Technical Service Bulletin

Cobra Motorcycle Mfg.

TSB0116

Mounting the 2016 King Radiator on Older King Models

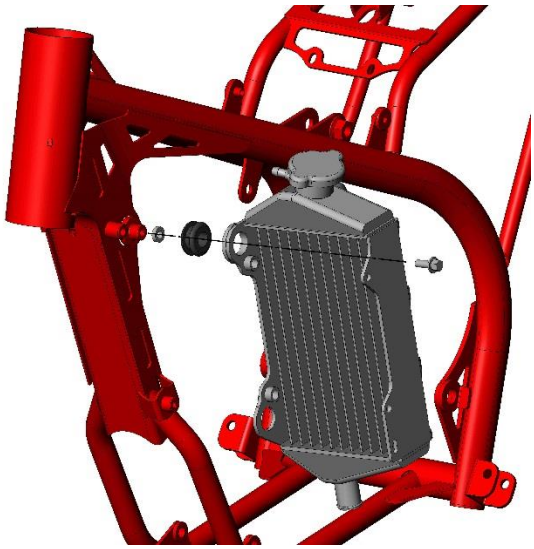
For 2016 the CX50 SR (King) radiator has been strengthened in the area of the upper radiator mount. The part number for this new radiator is FCCS0058.

For customers with older models that order the old part number FCCS0031 will automatically receive the new radiator, new thicker grommet (existing silencer grommet MCMUGR03), a spacer (FCCS0060) and a longer bolt (HCBF0620). This is all combined as a kit FKCS0002.

The spacer can be 'super glued' to the frame as it does not need to come off in the future. Its only purpose is to control the amount of 'crush' on the grommet.
